# Mobile Intel<sup>®</sup> Pentium<sup>®</sup> II Processor Specification Update

Release Date: July 2006

Order Number: 243887-053

The Mobile Pentium<sup>®</sup> II processor may contain design defects or errors known as errata which may cause the product to deviate from published specifications. Current characterized errata are documented in this Specification Update.

**Figure 1. An Example of Microcontroller Driven Thermal Management**

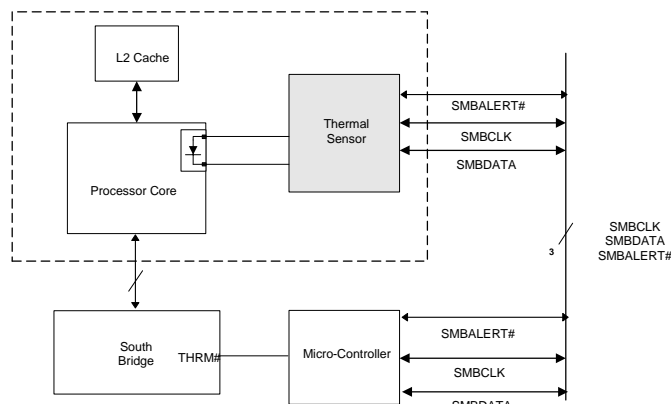
**Problem:** The Mobile Pentium II processor and the Pentium II Processor Mobile Module have a thermal sensor that monitors the processor core's temperature. Please note that desktop systems could have a similar thermal device. The thermal sensor asserts SMBALERT# if the processor temperature exceeds the temperature limits set in the Alarm Threshold Registers ( $T_{HIGH}$ ,  $T_{LOW}$ ). It also sets the corresponding Status Register bits to identify the cause of the interrupt. Figure 1 gives one example of the how the SMBALERT# signal could be used in a system.

Under the conditions described below, the thermal sensor incorrectly generates the SMBALERT# interrupt. All of the following conditions must be met to trigger a false interrupt:

**Figure 2. Workaround Flowchart: SMBALERT#-Driven System**

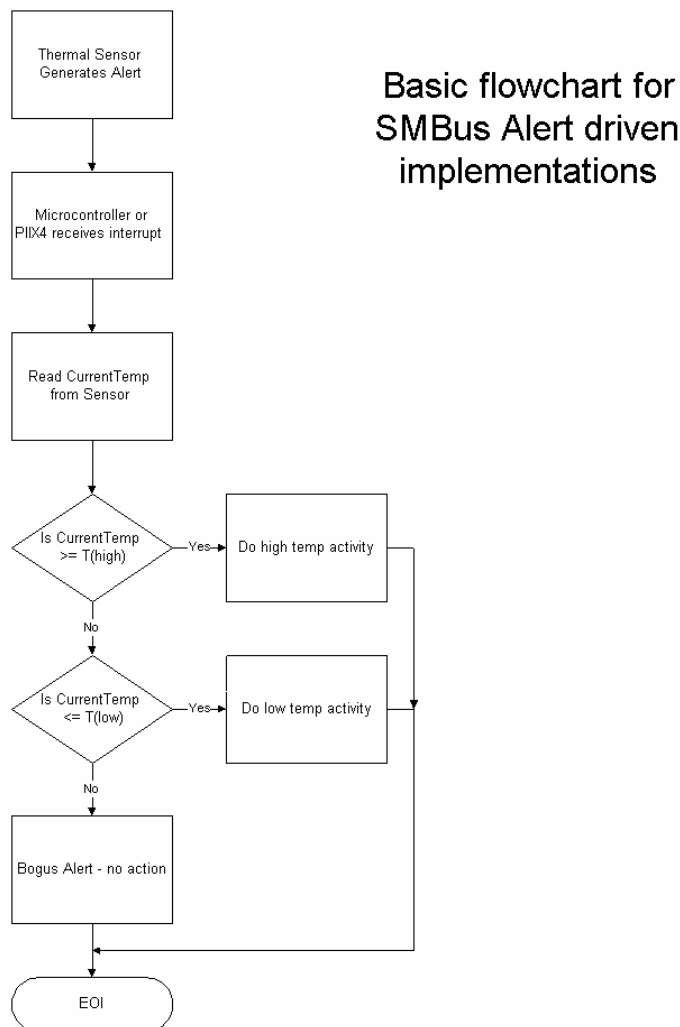
1. Before servicing an interrupt from the thermal sensor, read and compare the processor thermal reading with the threshold limits ( $T_{HIGH}$  or  $T_{LOW}$ ). Figures 2 and 3 provide basic flowcharts for the implementation of this workaround in an interrupt driven system.
2. If the firmware implemented polls the Status Register only, then before taking any action, re-read the temperature register and do a comparison with the alarm threshold limits ( $T_{HIGH}$  or  $T_{LOW}$ ) to determine if the value is actually still within the temperature window.

3. Use a temperature polling scheme to monitor the processor temperature.

Figure 1. TAP Gageable Thread Clarification

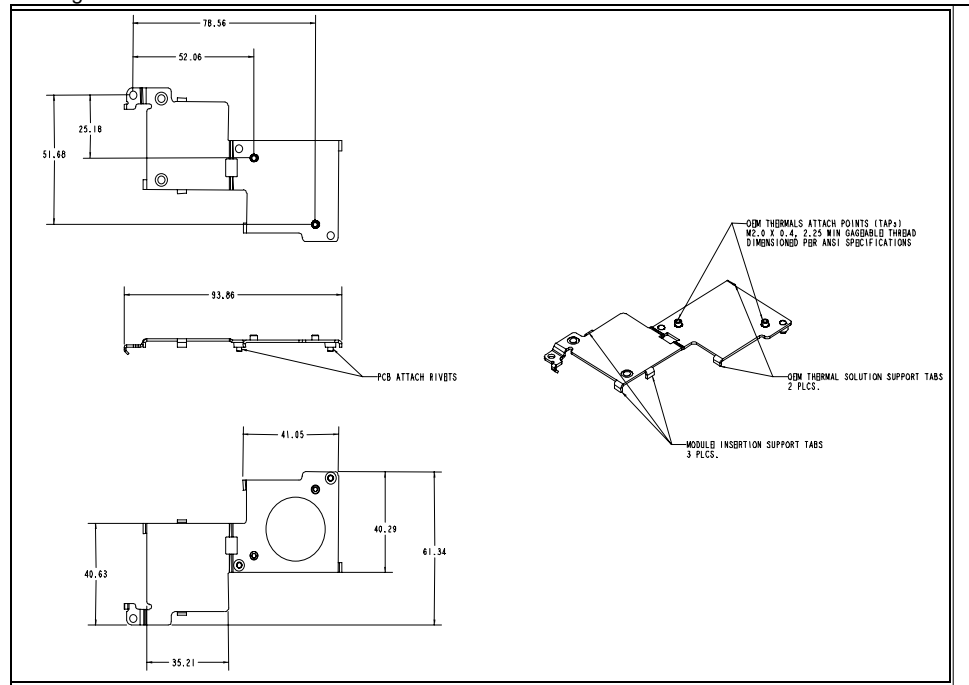
In the *Intel® Pentium® II Processor Mobile Module : Mobile Module Connector 1 (MMC-1)* and the *Intel® Pentium® II Processor Mobile Module : Mobile Module Connector 2 (MMC-2)* datasheets (Order Numbers 243667 and 243668, respectively), the thermal attach point (TAP) gageable thread specification was not clearly identified in Figure 14, of Section 5.2. The following is the TAP clarification:

OEM Thermal Attach Points (TAPs) M2.0 x 0.4, 2.25 min gageable thread dimensioned per ANSI specification.

See Figure 1 below for more information.
